**CCC Exhibit A**  
 (page 1 of 3 pages)

Subject: Application Number 02-0432

**RE: Appeal to Coastal Commission of Application Number 02-0432,  
APN 028-232-16**

**Re: *Letter re Borelli Appeal of Santa Cruz County Application # 02-0432,  
APN 028-232-16***

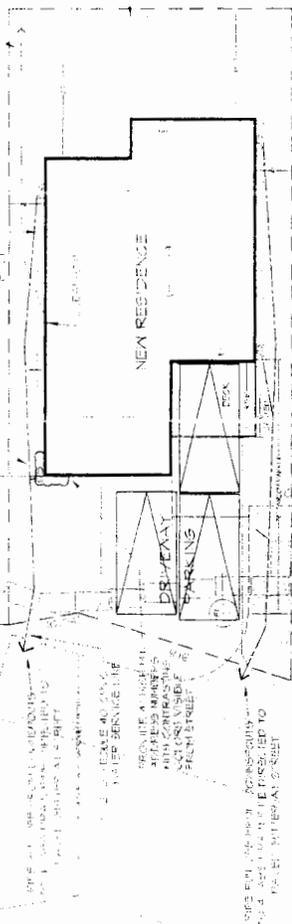
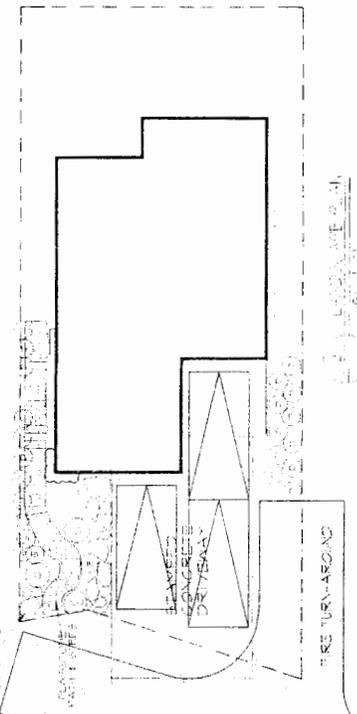
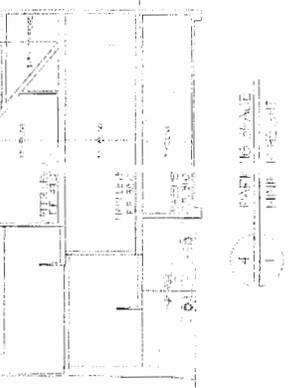
sheathing) and the upper side of the ceiling framing.” Attics do not have floors or ceilings. Please revise Section 4 on page 3 and Site statistics table #11, 13 and 18 on page one.

1. The roof plan indicated on the site plan is not consistent with the elevations.
2. The second floor window shown on the rear elevation does not appear on the second floor plan.
3. If the elevations are correct there is a 13' x 7' room on the second floor not shown.
4. The site plan does not accurately reflect the chimney projection shown on the elevations.

We have revised the site plan moving the house back the 4.5' as requested by the Coastal Commission Staff. The move has increased the amount of grading by at least 40 cubic yards and has increase the impervious surface for the driveway and walkway by some 130 square feet. This has increased the setback from the start of the down slope from 36' to 40.5'. The increased setback and proposed lowering of the height does not have anything to do with adherence to the required 25-foot setback, as the proposed structure is now over 40- feet back from the start of the coastal bluff. Changing the height, which is in compliance with the Regulations, will not change the impact on the coastal bluff in any way.

1. “The roof plan indicated on the site plan is not consistent with the elevations.” **The Architect and I have reviewed the plans and elevations and found the site plan shows the first roof design (five years old). We have revised the site plan, and roof plan, with the fireplace base footprint. (See revised sheet one).**

4. “The site plan does not accurately reflect the chimney projection shown on the elevations.” **The site plan shows the footprint as it is required to do. We have added a line to show the footprint of the chimney and deck projections as well as the covered porch projections. (See revised sheet one)**

ELEVATIONS  
/ADEN REY RESIDENCE

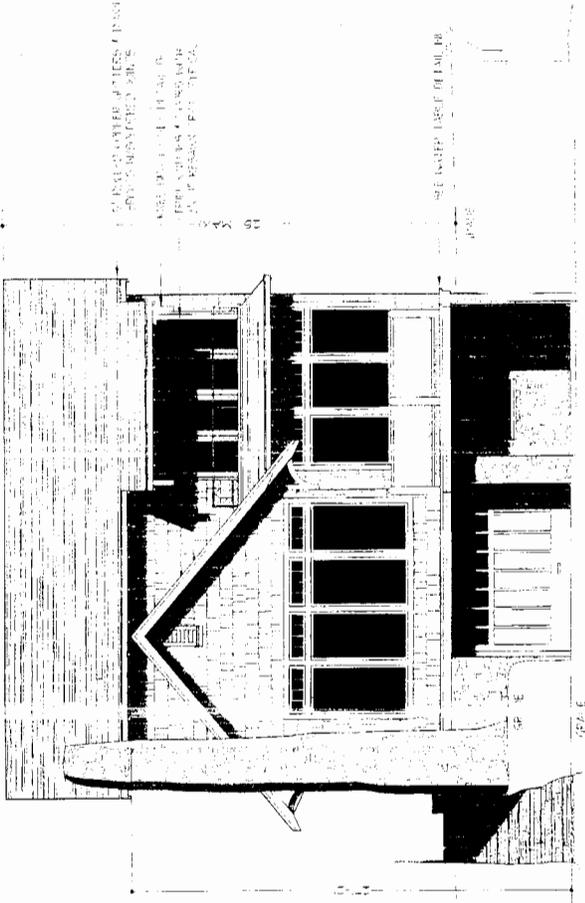
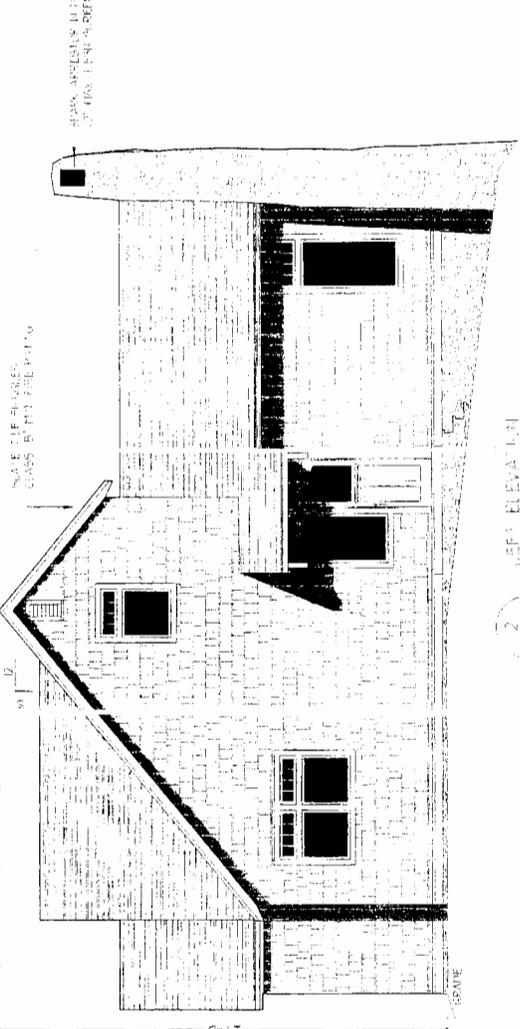
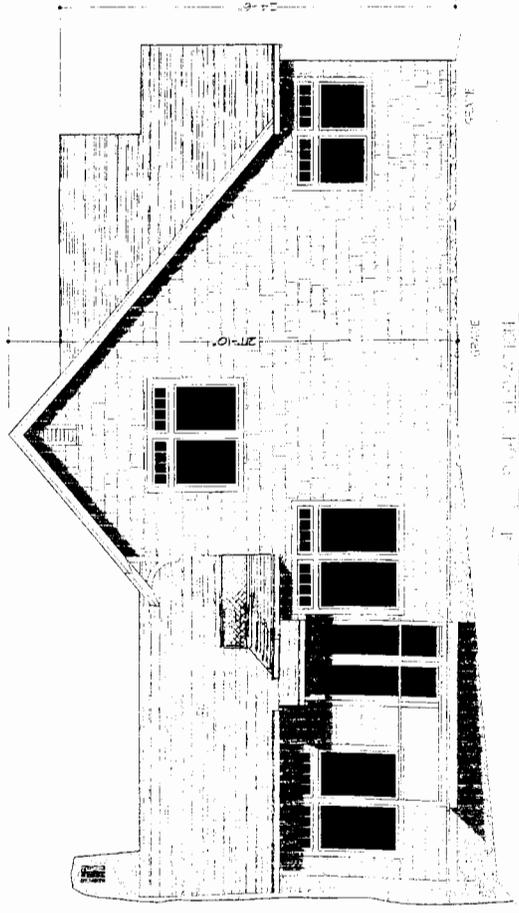
3. The master bedroom deck is dimensioned at 6 feet while the south elevation scales at 3 feet.

1. The attic area as designed and shown is not habitable space. The County reviewed the proposal and agreed that the attic area was not to be included in the building area. The Site statistics table #11, 13, and 18 on page do not need to be revised.
2. We have not included the "attic area" in the F.A.R. because it is not part of the floor area.
3. The South Elevation was Revised to show deck  $\bar{a}$  6 feet. Please see sheet two marked REV 1/27/09.

3. “--- there is a 13' x 7' room on the second floor not shown.” **The elevations are correct; the space is the attic area on the second floor. (See revised sheet three we have revised the right and left elevations to reflect the smaller final footprint).**

Visual Simulation of Proposed House

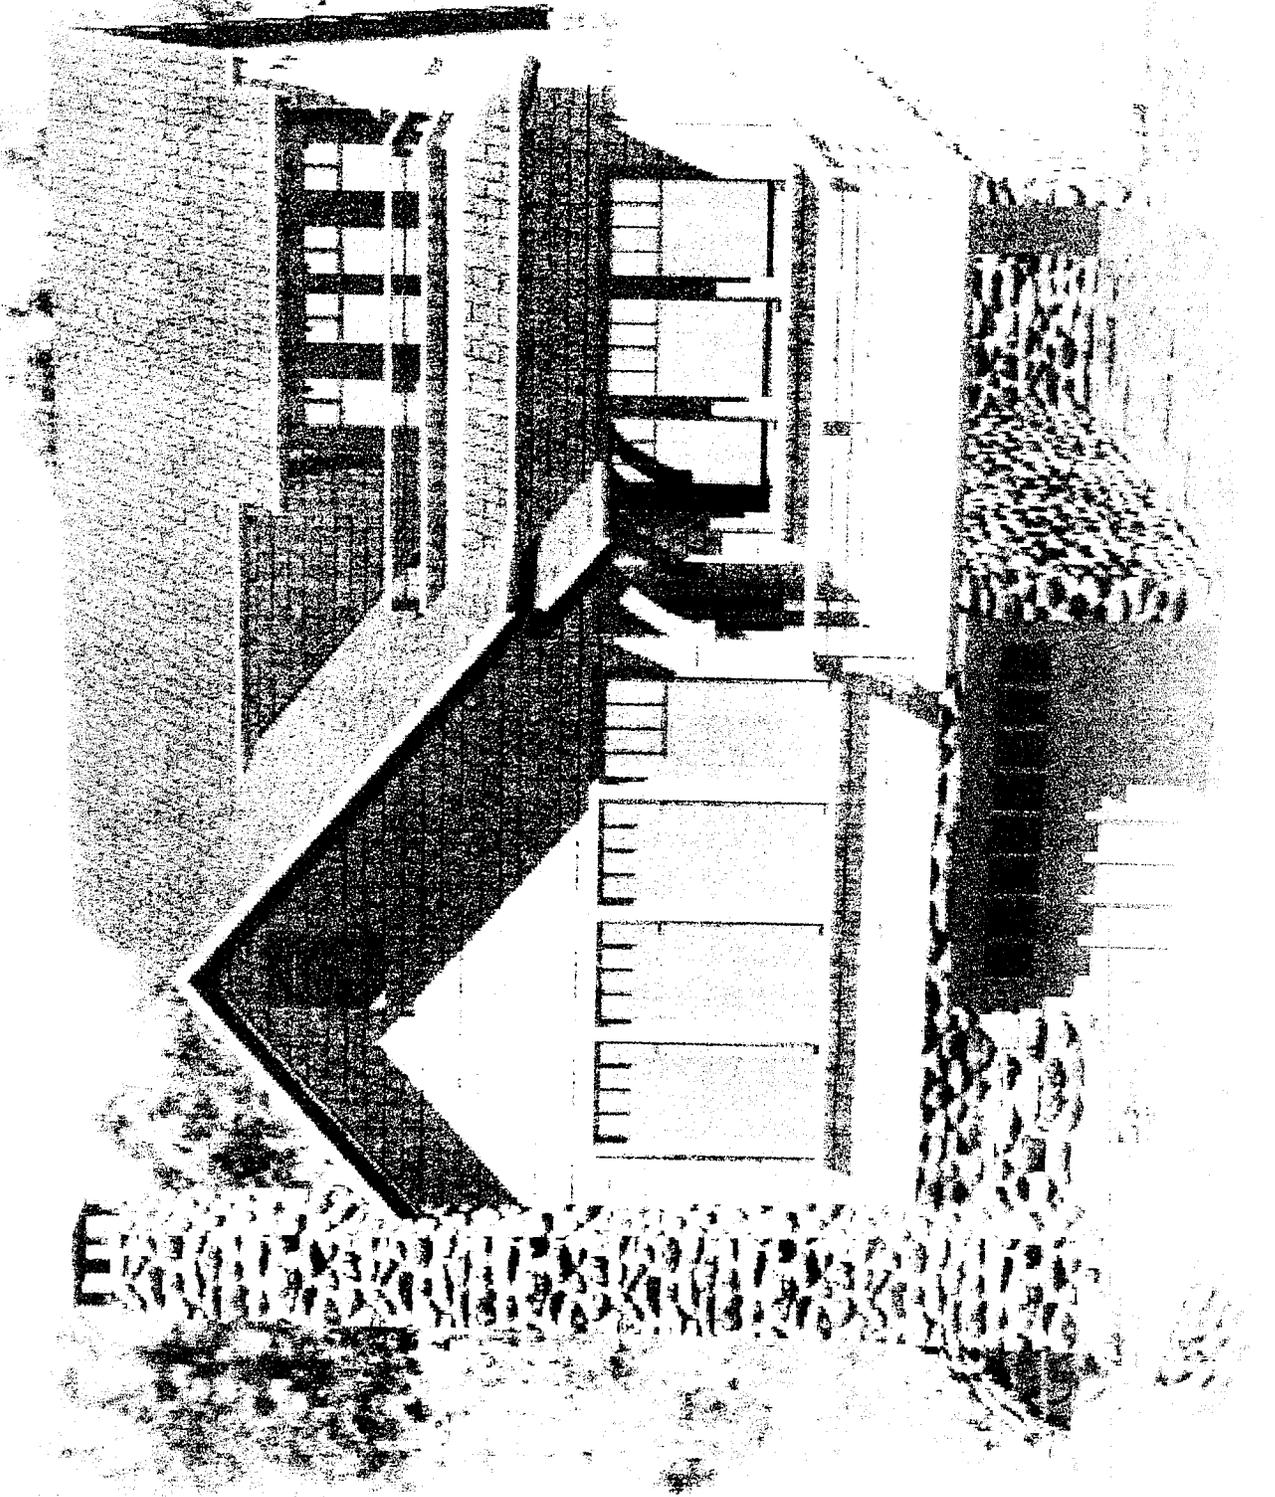
1. The applicant should be required to erect story poles on site to give everyone a better sense of the impact of this project.
2. Overall height and bulk of this home can be easily reduced over 5' by lowering the proposed ceilings from 10' to 8' and lessening the roof pitch from 10 to 8.
3. Moving this home toward the rear property line as required by the County Planning Commission would minimize the impact to the bluff (as well as the adjacent property owner). This required change needs to be shown on the plans so that the reference in the CDP conditions

**not believe this was necessary to understand the compatibility and effect on the area. The project as proposed does not change any public views of the Bay. We would only install story poles if required by the Coastal Commission Staff. We have included copies of a computer generated perspective of the house and the streetscape with the house added. (See Exhibit A and B.)**

RUE 12-2-8

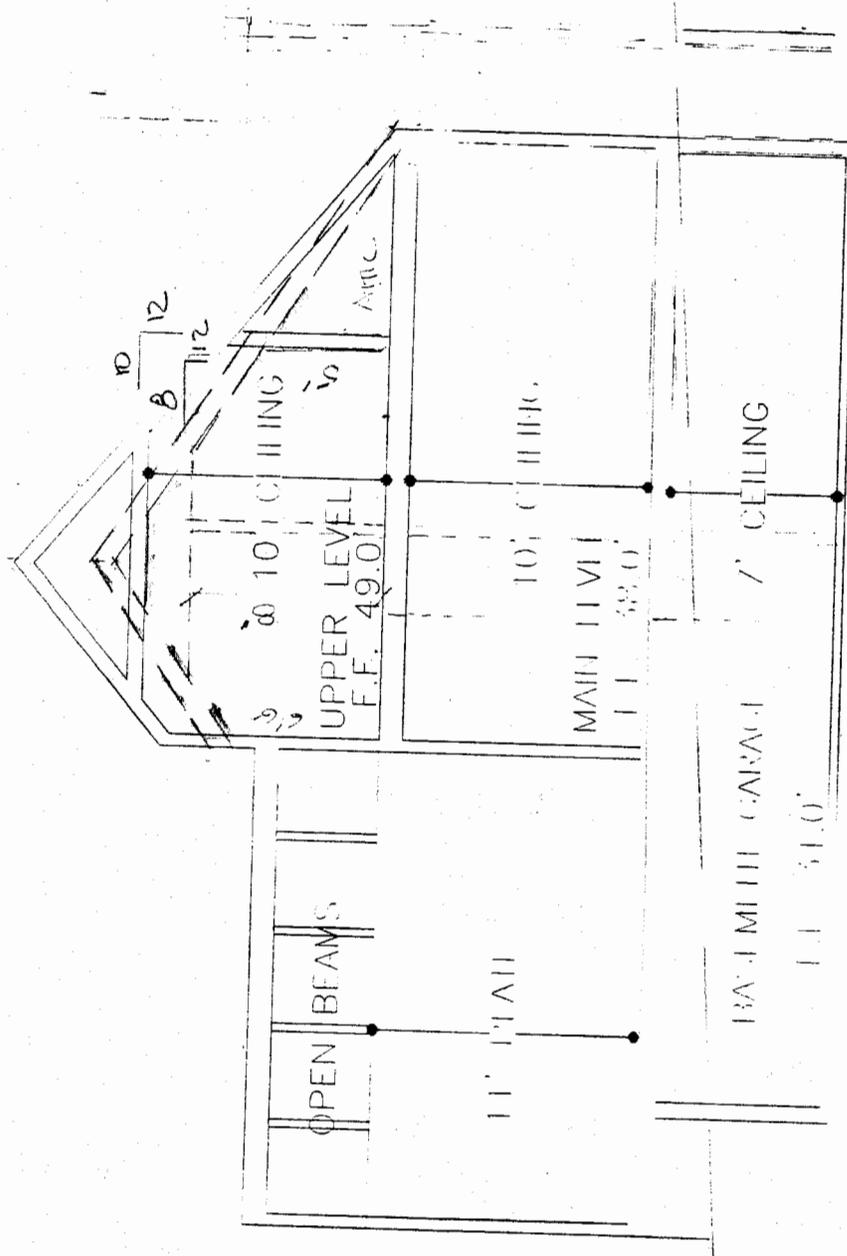
2. Exhibit C dated December 2, 2008 - Roof pitch can be reduced to 8/12 and the overall height lowered by 21 inches without affecting the interior wall by raising the eastern plate 14 inches and lowering the western plate 12 inches.

As previously stated, we do not believe there is any reason to reduce the building height or proposed 10 ceilings. The project has been reviewed by the Urban Designer, who has determined the proposal complies with the requirements of the County Design Review Ordinance and the Local Coastal Program. (Please review the Design Review Section by Urban Planner listed in the staff report listed on page 10 of the Zoning Administrator staff report). The suggestion that the ceilings be lowered and roof pitch lowered seem very subjective. It does not seem to be merited; the proposal meets all of the requirements of the Design Review Ordinance and Local Coastal Program. The proposed structure is almost the same height when viewed from the West as is the Appellant's residence. We believe that the suggested changes would make the project less combatable with the variety of residential design along 23<sup>rd</sup> Avenue including the Appellant's residence. (Please see Exhibit C which is sketch by RLE dated 12-2-8 which shows the impact changing the roof pitch would have on the upper level).

2. **“Overall height and bulk of the home can be easily reduced by over 5’ by lowering the proposed ceilings from 10’ to 8’ and lessening the roof pitch from 10 to 8.” We do not believe there is any reason to reduce the building height or proposed 10 ceilings. The project has been reviewed by the Urban Designer, who has determined the proposal complies with the requirements of the County Design Review Ordinance and the Local Coastal Program. (Please review the Design Review Section by Urban Planner listed in the staff report listed on page 10 of the ZA staff report). The suggestion that the ceilings be lowered and roof pitch lowered seem very subjective. It does not seem to be merited; the proposal meets all of the requirements of the Design Review Ordinance and Local Coastal Program. The proposed structure is almost the same height when viewed from the West as is the Appellant’s residence. We believe that the suggested changes would make the project less combatable with the variety of residential design along 23<sup>rd</sup> Avenue including the Appellant’s residence. (Please see Exhibit C which is sketch by RLE dated 12-2-8 which shows the impact changing the roof pitch would have on the upper level).**
